Metro Inner-South Joint Development Assessment Panel Agenda

Meeting Date and Time: Tuesday, 25 July 2023; 9:30am
Meeting Number: MISJDAP/153
Meeting Venue: Electronic Means

Local government	City of Canning	
Item 4.1	Ten Multiple Dwellings – 41 Wendouree Road (Lot 3), Wilson (City ref: 105.1328)	
Date	Tuesday, 16 May 2023	
Time	9.30am	
Location	Committee Room at the City of Canning Administration Offices 1317 Albany Highway, Cannington	
Panel members	Emma Williamson Tony Blackwell	Chair (Architect) Member (Landscape Architect/Urban Designer)
Local government officers	Sergio Famiano Adam Prestage Barb Rankin	Manager City Planning Planning Officer Executive Assistant, Planning & Development
Proponent/s Group	Liz Wong Malcolm Mackay	Project Development Consultant, Tuscom Subdivision Consultants Architect Consultant, Tuscom Subdivision Consultants
Observer/s	Nil.	
Briefings		
Development assessment overview	Adam Prestage	Planning Officer, City of Canning
Technical issues	• Façade of building addressing the street is somewhat lacking in design finesse; • Car parking location and design, including configuration and compliance; • Inappropriate waste, i.e., roadside waste collection propo

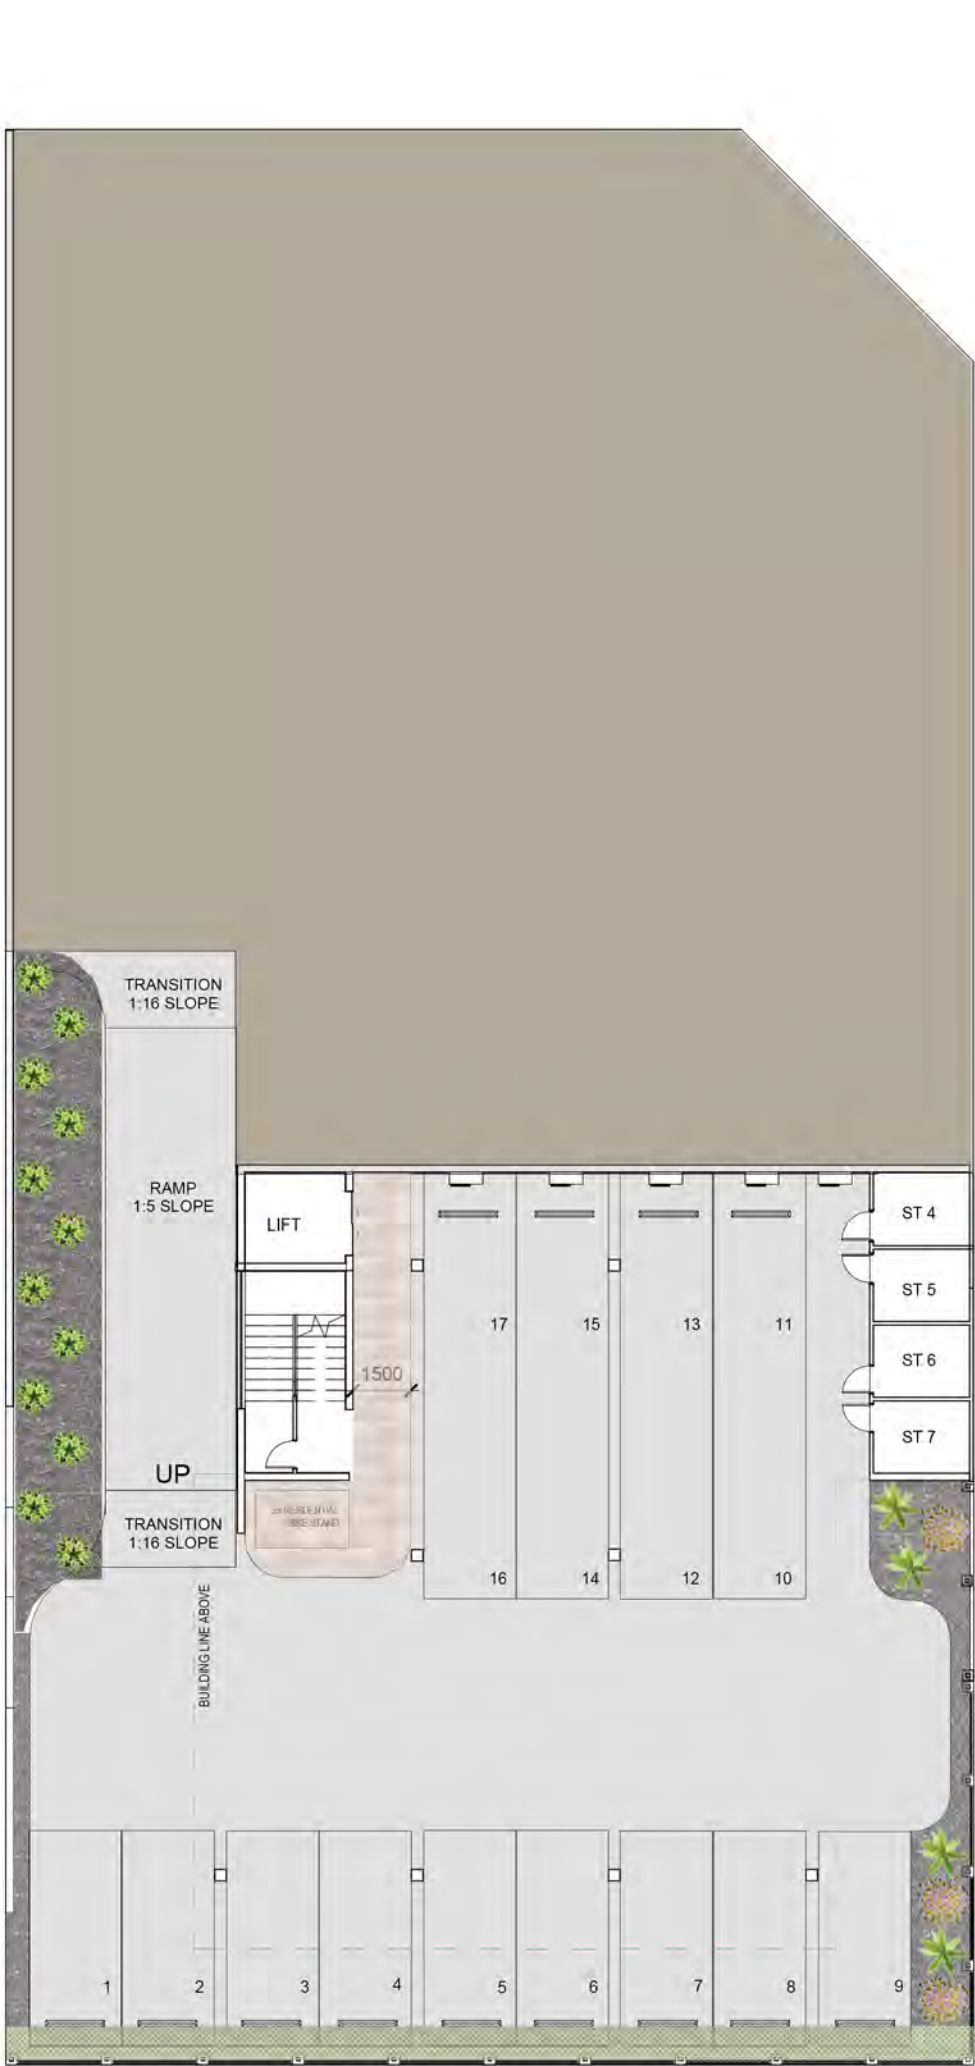
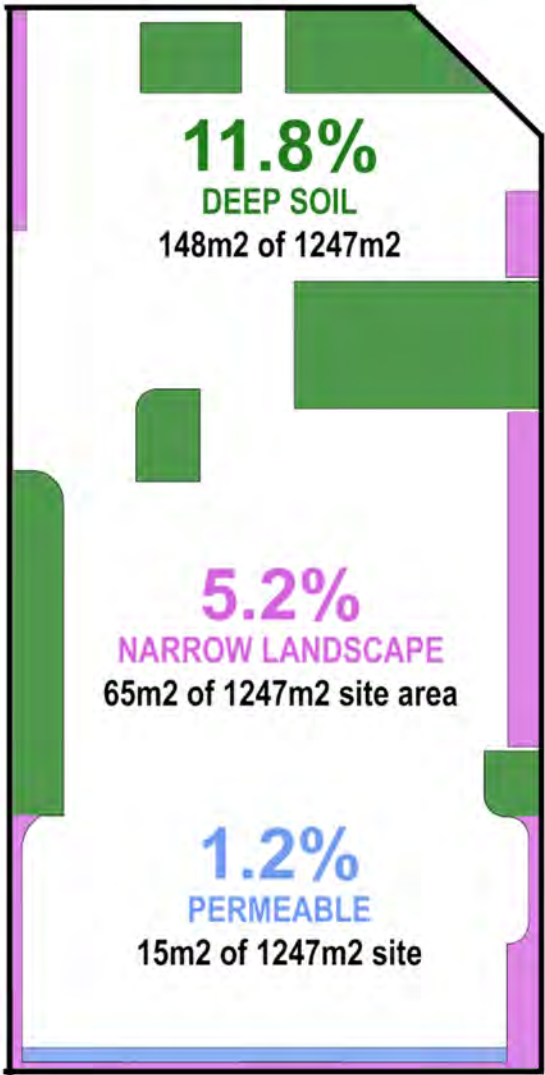
The City Officers have reviewed the amended landscaping plan and are generally supportive of the changes made to species and layout. However, it has been noted that it is not feasible to maintain a strip of natural turf along the rear boundary of the carpark.

A planting of shrubs is required, which will help to soften the appearance of the fence from the park. Also, the DRP requested the use of native species within the development due to the proximity to the river. An alternative tree species to *Magnolia grandiflora* is required.

4.12 - Landscape Design	O4.12.1 – Landscape design enhances streetscape and pedestrian amenity; improves the visual appeal and comfort of open space areas; and provides an attractive outlook for habitable rooms. O4.12.2 – Plant selection is appropriate to the orientation, exposure and site conditions and is suitable for the adjoining uses. O4.12.3 – Landscape design includes water efficient irrigation systems and where appropriate incorporates water harvesting or water re-use technologies. O4.12.4 – Landscape design is integrated with the design intent of the architecture including its built form, materiality, key functional areas and sustainability strategies.	The proposed development generally meets requirements, and this has been improved as per DRP comments. However, the amended landscaping plan still needs improvement and further changes are required to fully meet issues raised by the City and DRP. Removal of lawn proposed to the rear of the site in the updated landscape plan is required. This should be replaced with shrubs to help soften fencing to the rear. Furthermore, some tree species need replacing as per City Officer's comments and DRP advice. Due to the close proximity to the Canning River and ecological importance of the area the landscaping amendments are important to the proposed development. Some species proposed are not native and endemic to the area and therefore should not be included. A condition has been included in this regard.

9. Prior to the submission of an application for building permit, the Landscape Plan received 20 June 2023 shall be amended to the satisfaction of the City of Canning.

As there are minor outstanding items to satisfy, a condition has been included requesting an amended landscape plan to be submitted prior to building permit application.
